NEWMAN CROSSING SUBDIVISION,
UNIT TWO, RESUBDIVISION OF LOT 55

APPLICATION NUMBER 3 DATE September 21, 2017
APPLICANT Newman Crossing Subdivision, Unit Two, Resubdivision of Lot 55
REQUEST Subdivision

DETAIL SITE PLAN

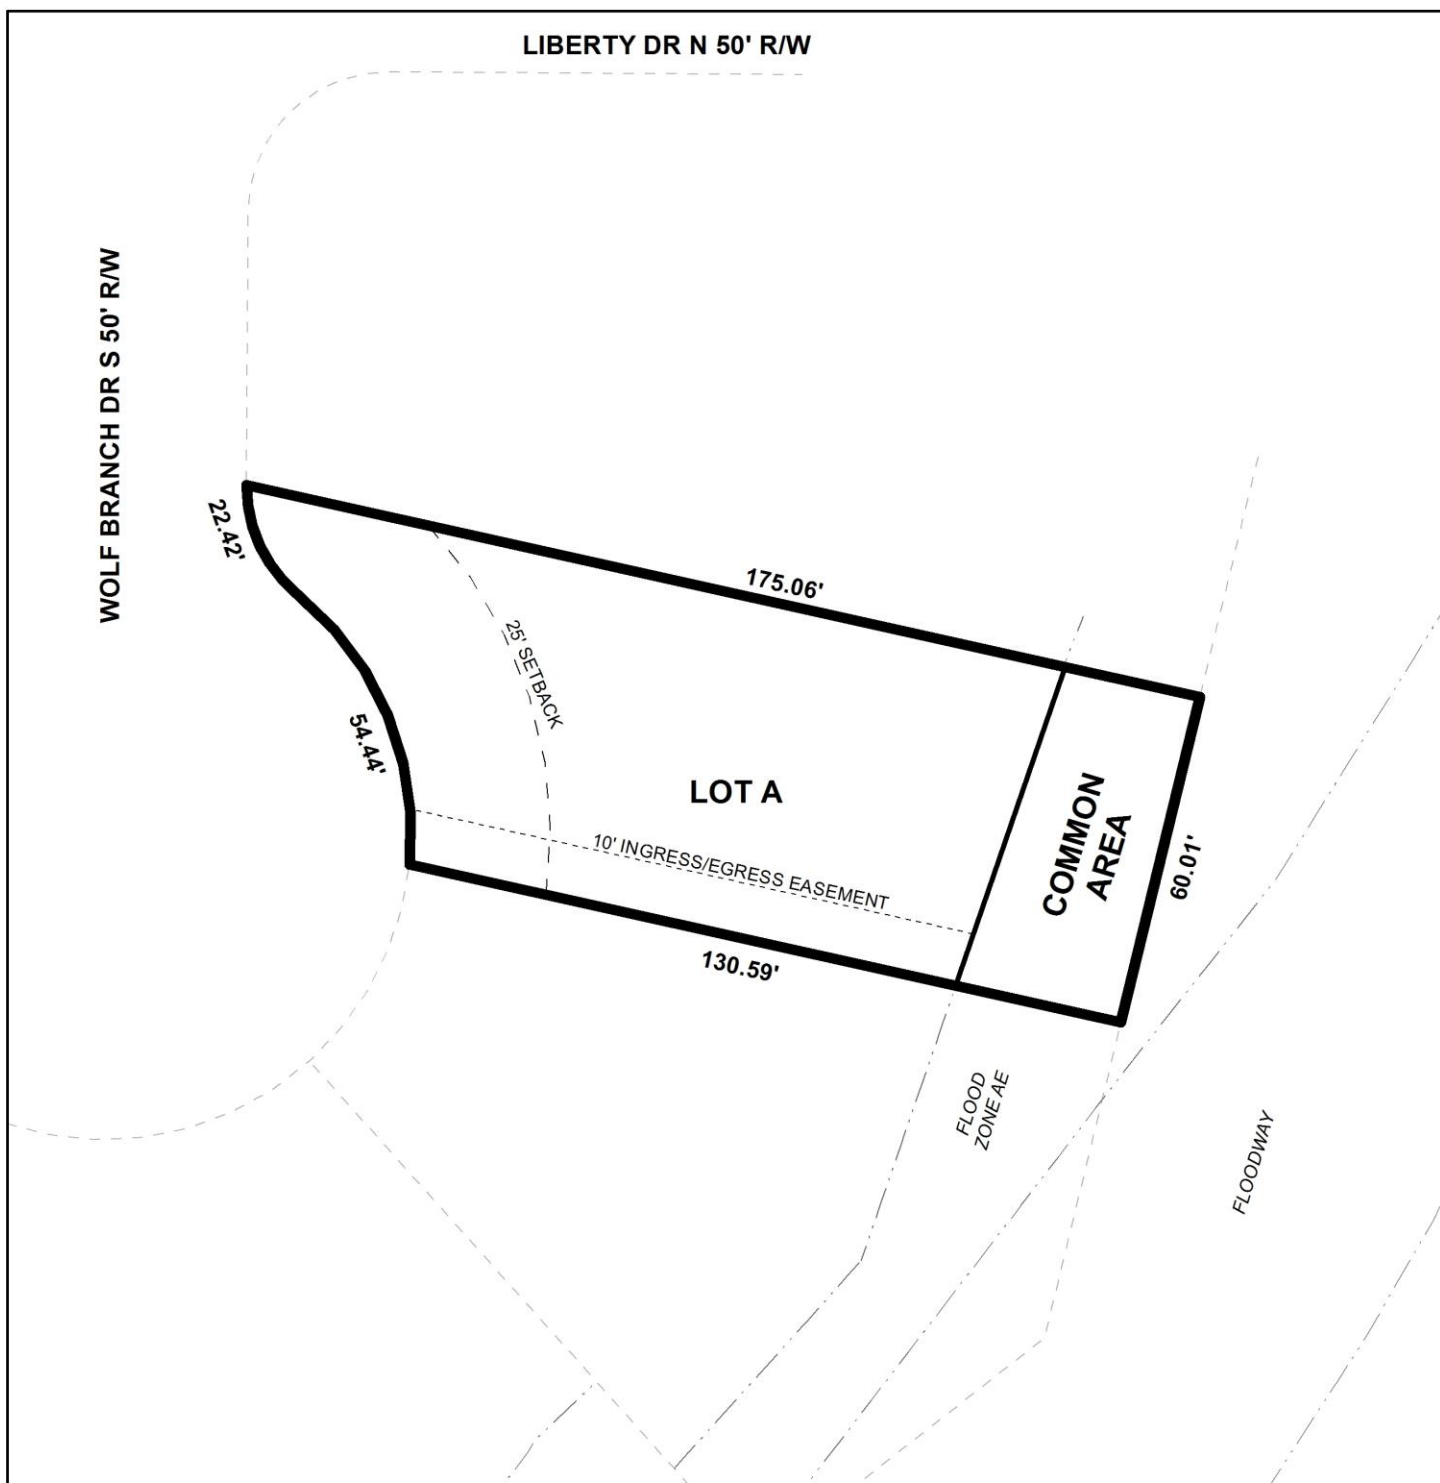
The proposed lot fronts Wolf Branch Drive South, a minor arterial street with ribbon curb and gutter. As a minor arterial street with ribbon curb and gutter, this street requires a 50' wide right-of-way width. The existing right-of-way width is depicted as 50' on the preliminary plat and should be retained on the Final Plat, if approved.

The 25-foot minimum building setback line is depicted on the preliminary plat, and, if approved, should be retained on the Final Plat.

The lot size information is depicted in both square feet and in acres on the preliminary plat and should be retained on the Final Plat, if approved.

The applicant submitted a revised site plan depicting a 10' wide access easement located along the southern perimeter of the proposed Lot A for ingress and egress to the proposed common area; however, this access easement still does not provide access to the common area located north of Liberty Drive North. Furthermore, the site plan still does not illustrate both the "future development" parcel, and the common area sited to the north of Liberty Drive North.

As stated at the last meeting, the proposed common area would not be contiguous with the other common area located on the on the north side of Liberty Drive North, as indicated on the 2008 plat. The proposed common area does not illustrate connectivity to the larger common area of the subdivision, and as such, is not sufficient.

- 1) The proposed common area does not provide access to the existing common area located on the north side of Liberty Drive North; and
- 2) The site plan does not illustrate both the “future development” parcel and the common area located on the north side of Liberty Drive North.

- 1) revision of the plat to depict an access easement or similar to the proposed common area; and;
- 2) provide information regarding the maintenance responsibility or the common area.
